P.O.A.D.P. PLAN
for
EISENHAUER ROAD 13.5

Re: Eisenhower Rd. 13.5

POADP # 582

REQUEST FOR REVIEW

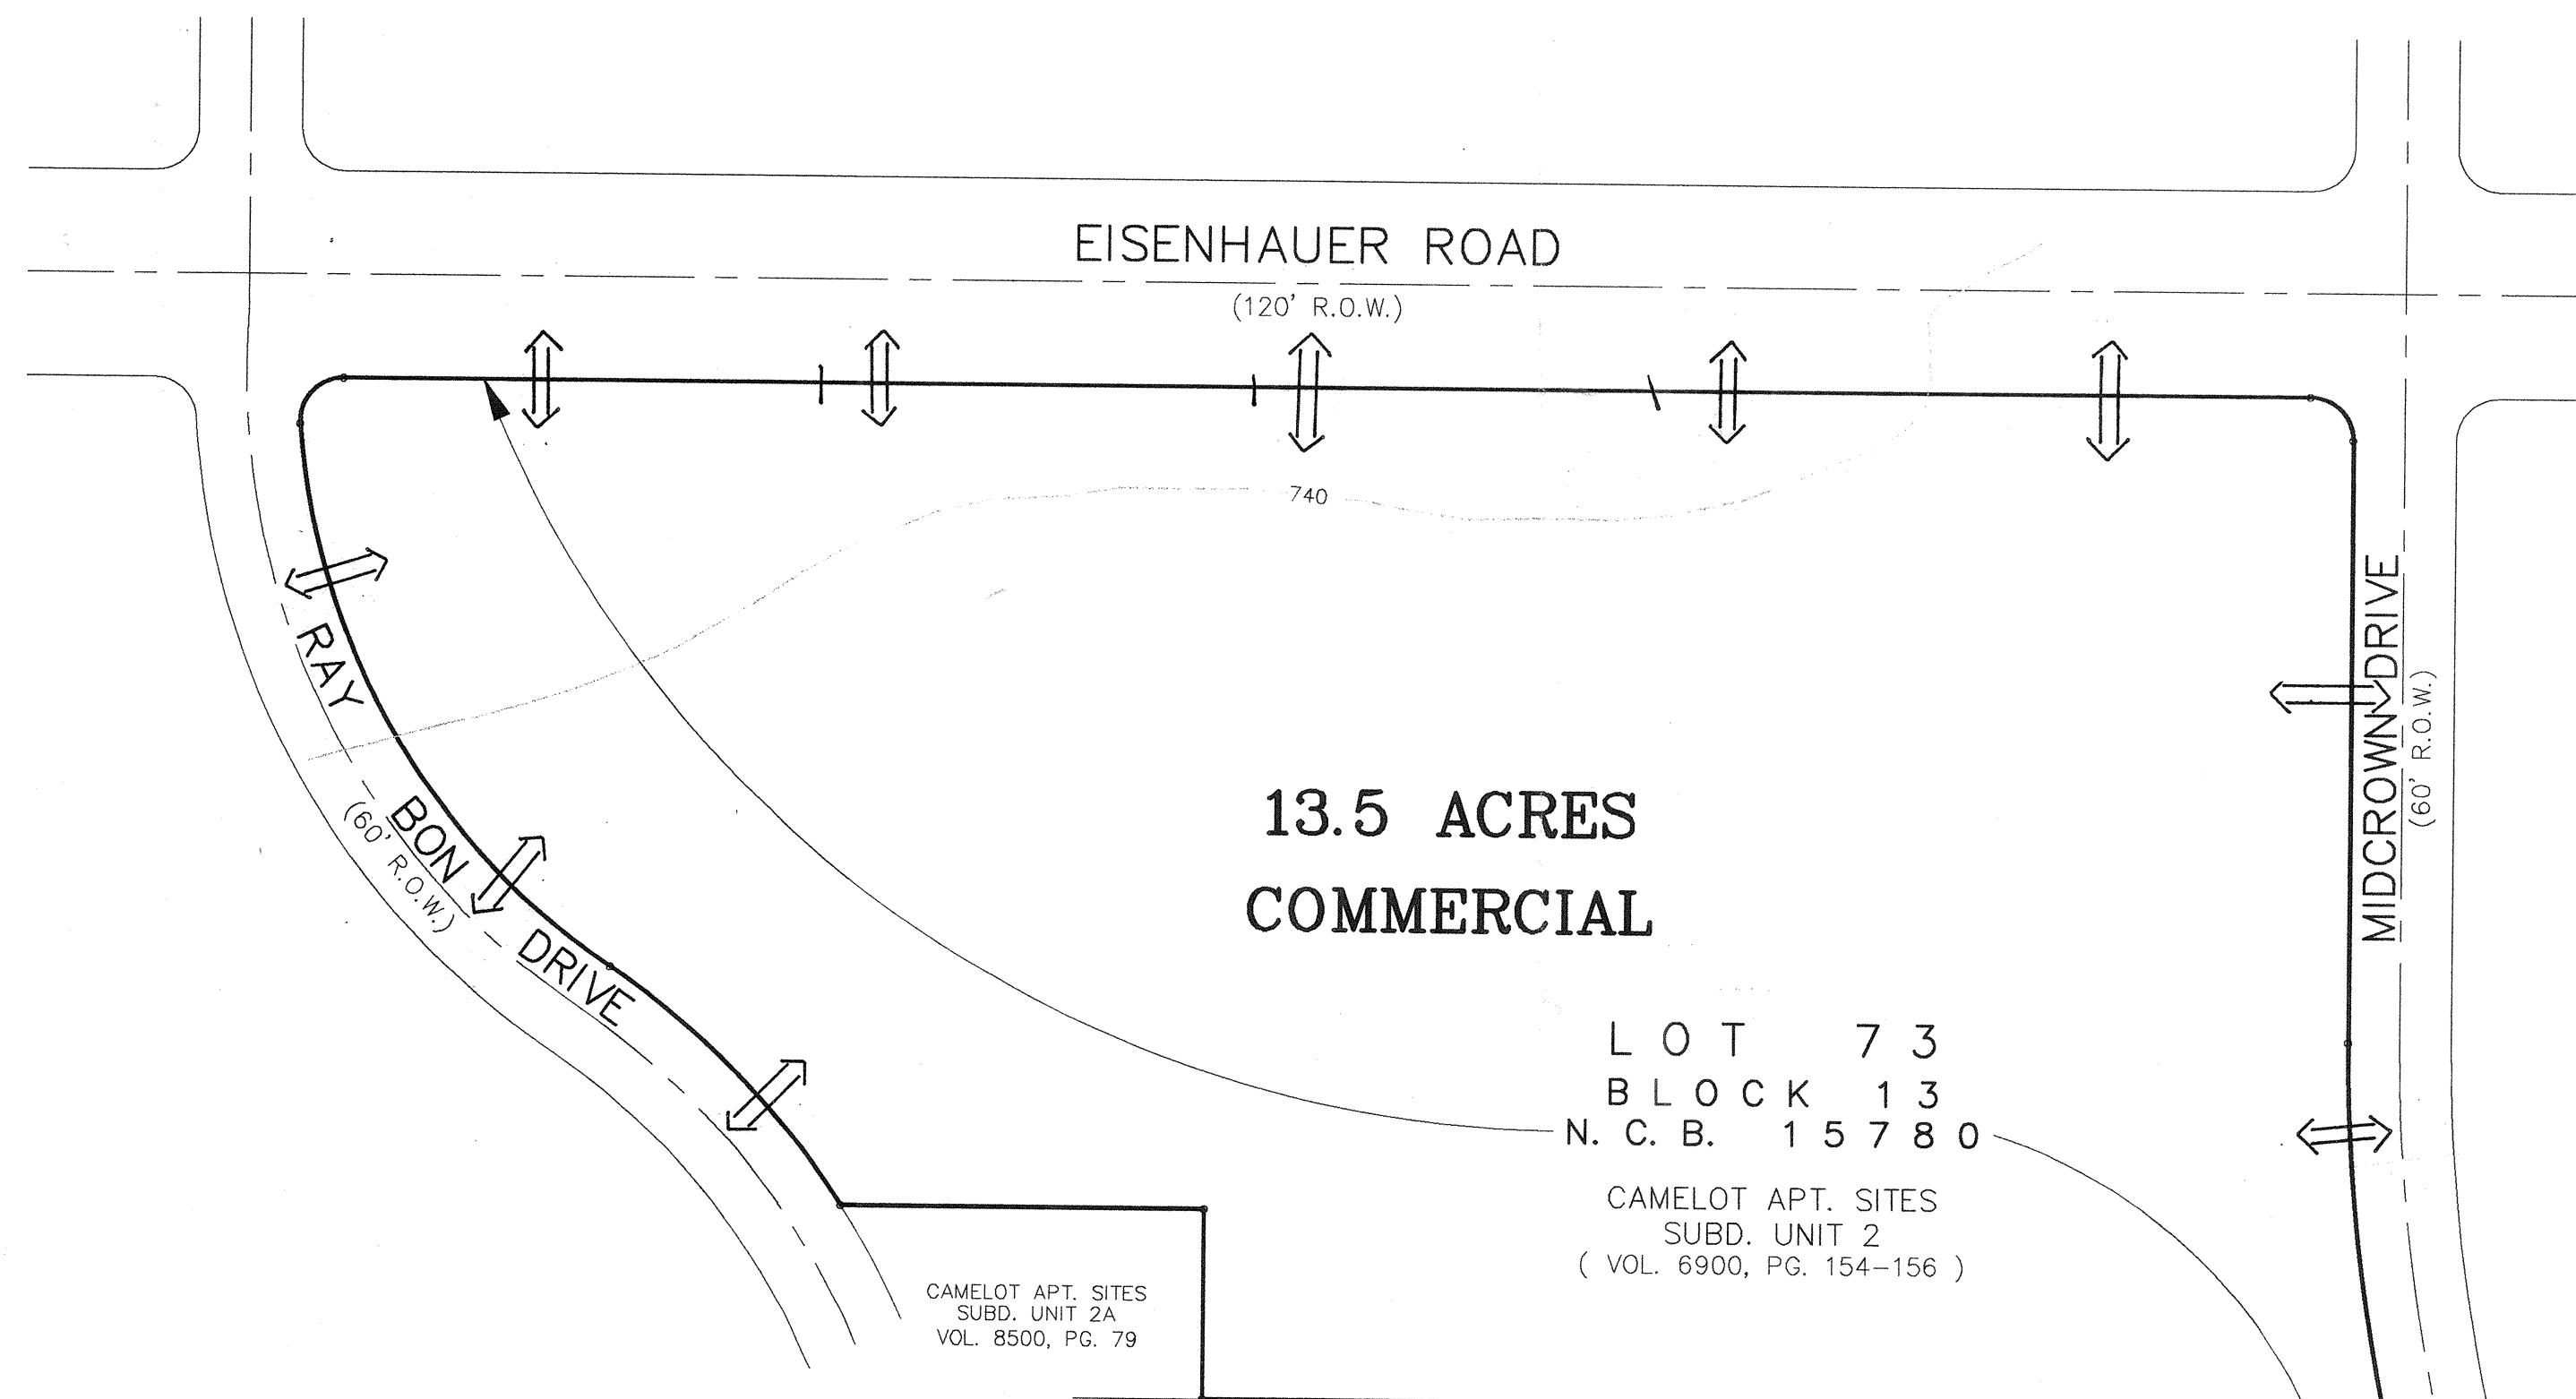
- Based on the topography, a Flood Plain Study and drainage review will probably be required during the platting process.
- This development will need to comply with tree preservation ordinance #85262. For additional information about these requirements you can contact Building Inspections at 207-7102.

*Drainage easements maybe require and
will be address during the platting process.*
